City of Portland, Maine – Building or Use Permit Application 389 Congress Street, 04101, Tel: (207) 874-8703, FAX: 874-8716

Location of Construction: <i>100 Devon St</i>		Owner: <i>Eleanor M Vane</i>		Phone: <i>871-8992</i>		Permit No: <i>970781</i>	
Owner Address: <i>100 Devon St - Portland Me</i>		Lessee/Buyer's Name: <i>04102</i>		Phone:		BusinessName:	
Contractor Name: <i>David Hanscom</i>		Address:		Phone:		<div style="border: 2px solid black; padding: 5px; text-align: center;"> PERMIT ISSUED JUL 23 1997 CITY OF PORTLAND </div>	
Past Use: <i>1- fam</i>		Proposed Use: <i>1- fam w mud room</i>		COST OF WORK: <i>\$ 3000</i>		PERMIT FEE: <i>\$ 35</i>	
				FIRE DEPT. <input type="checkbox"/> Approved <input type="checkbox"/> Denied		INSPECTION: Use Group <i>R3</i> Type: <i>5B</i> <i>BOCA 95</i>	
Proposed Project Description: <i>constructed addition</i>				Signature:		Signature: <i>Hoffe</i>	
				PEDESTRIAN ACTIVITIES DISTRICT (P.A.D.)		Zone: <i>R-3</i> CBL: <i>284-B-36-37</i> Zoning Approval: <i>OK with comments</i> Special Zone or Reviews: <input type="checkbox"/> Shoreland <input type="checkbox"/> Wetland <input type="checkbox"/> Flood Zone <input type="checkbox"/> Subdivision <

Original plans
Bldg permit # 97098

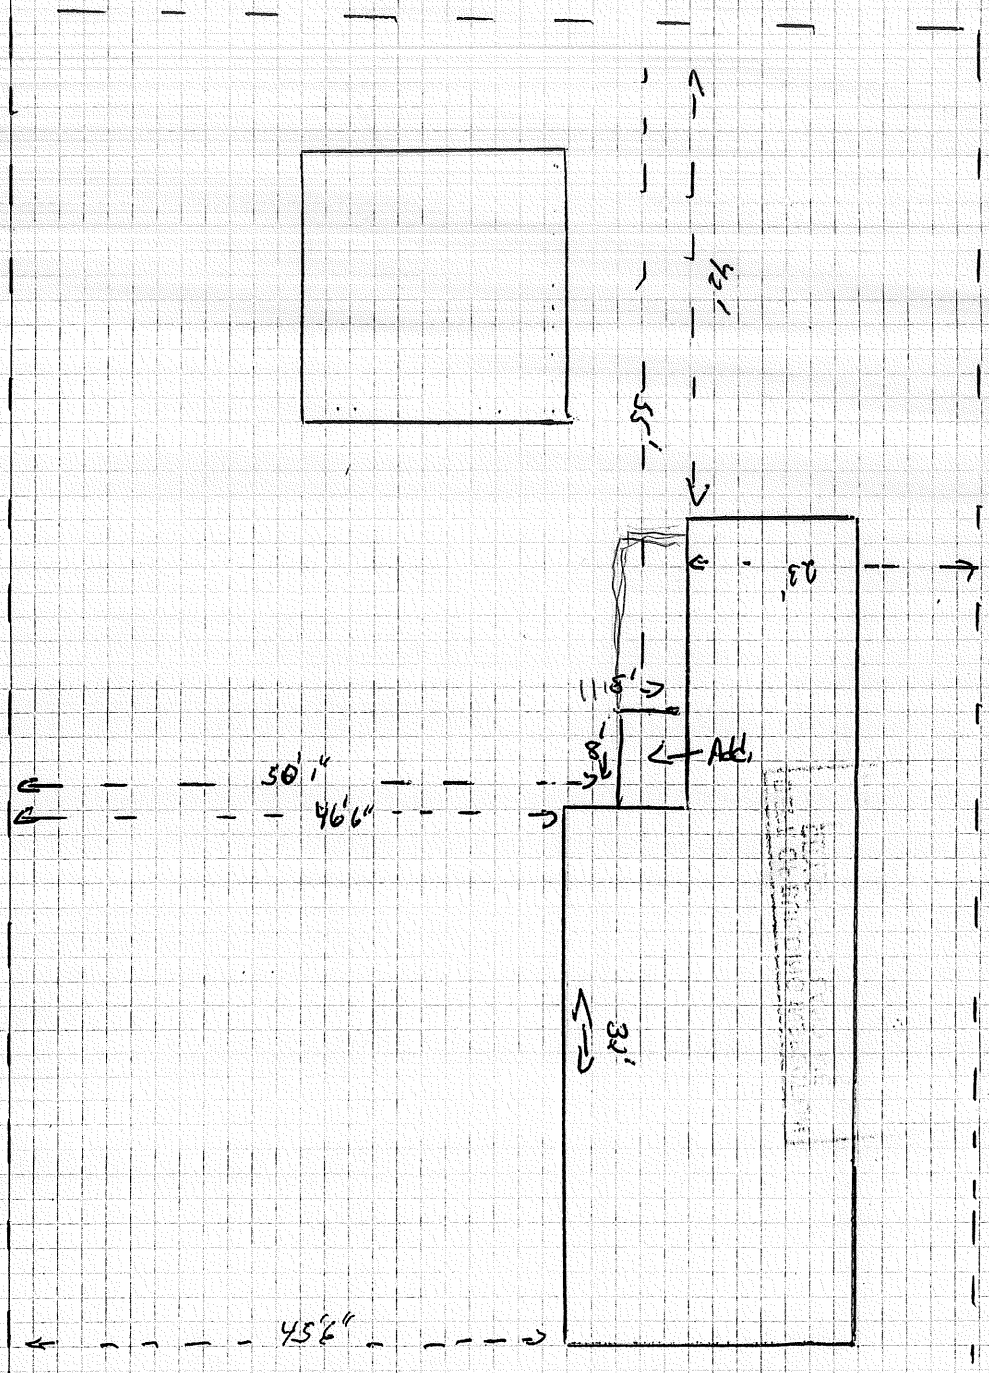
R-3 Zone

Req.
Front setback 25'
Side setback 8'

OK
